```
Council Agenda - Agenda Item 8.3 - Attachment 4
Representations - Conway and McKenzie Streets, Mowbray
6 December 2018
```

am writing to make this representation against DA0563/2018 'Proposed Wash Bay at 14-26 Conway Street Mowbray'. It is my assertion that the proposed wash bay development will be detrimental to the amenity of nearby residences and does not satisfy the requirements of the Launceston Interim Planning Scheme 2015.

I am writing to make a representation against DA0563/2018 'Storage - Construction of a building for use as a wash bay/car detailing in association with car storage' at 24-26 Conway Street Mowbray'.

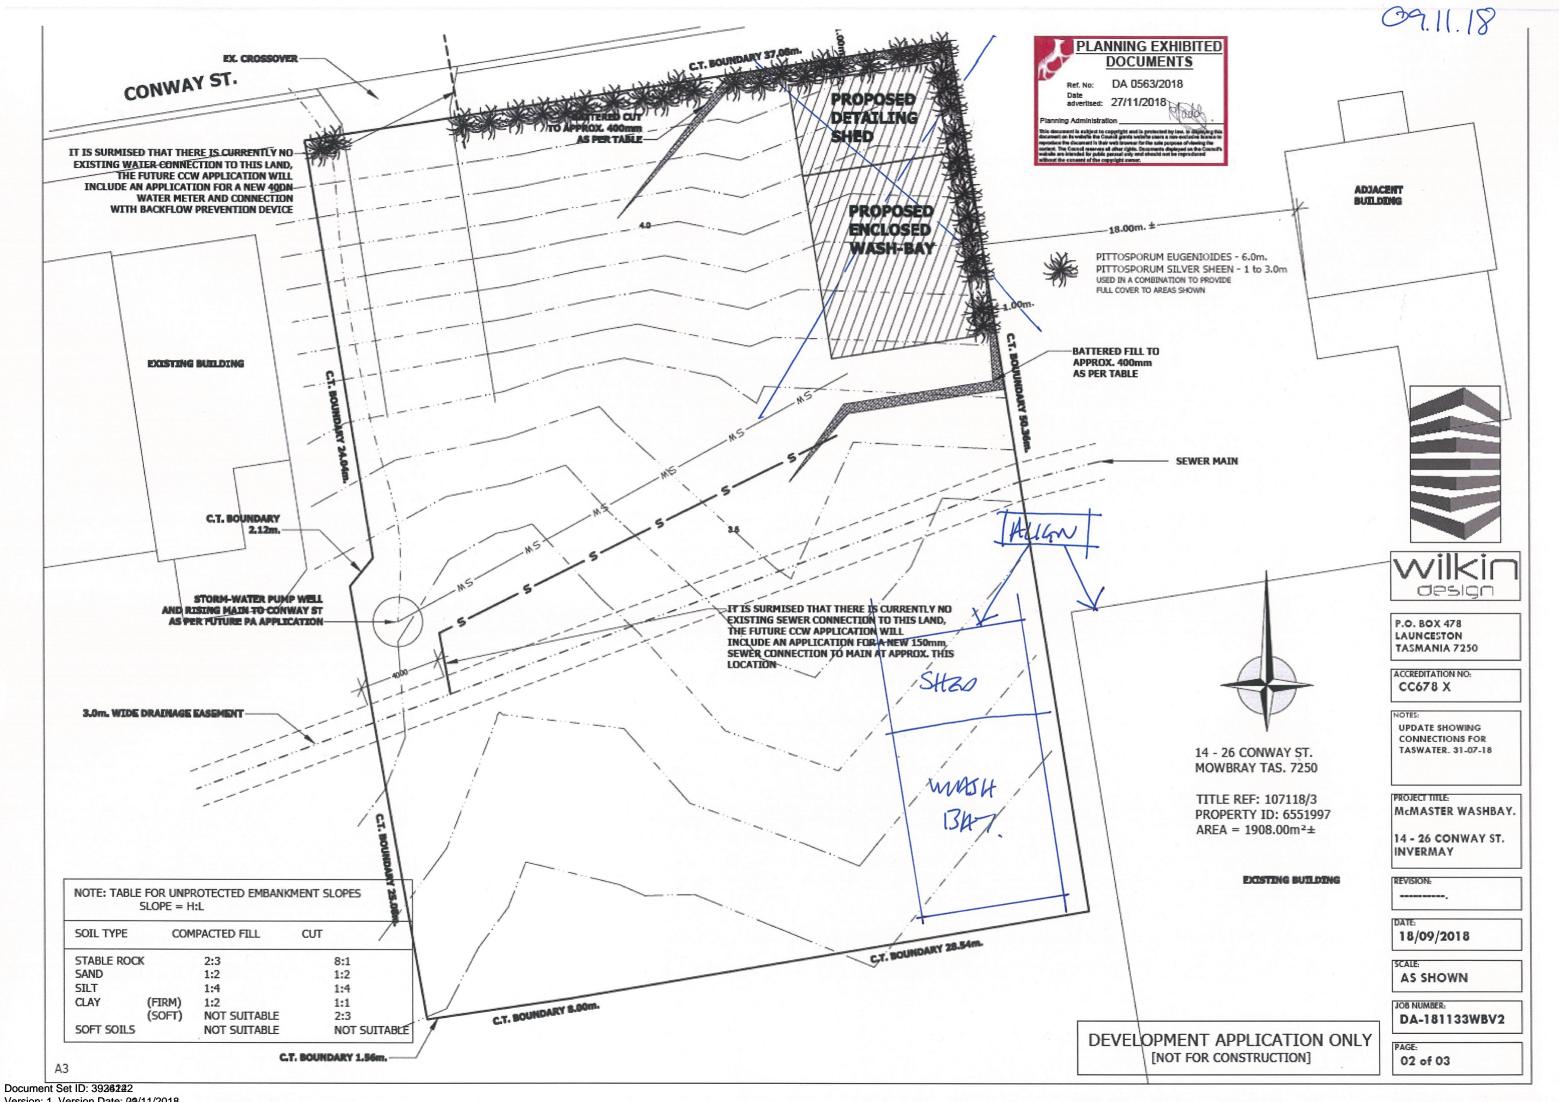
I have attached a response to the latest comments provided by the applicant and a site plan indicating where I would accept the building being located. This location will not have any effect on the ability of the applicant to maximise its use of the site.

Lastly, the applicant states that the wash bay 33m away and is uphill (sic) some 3m from the nearest residence. This residence to be identified. The applicant also states that "it would be <u>impossible</u> for any spray to find its way across the street'. This is a completely unsubstantiated statement and needs to be substantiated by modelling.
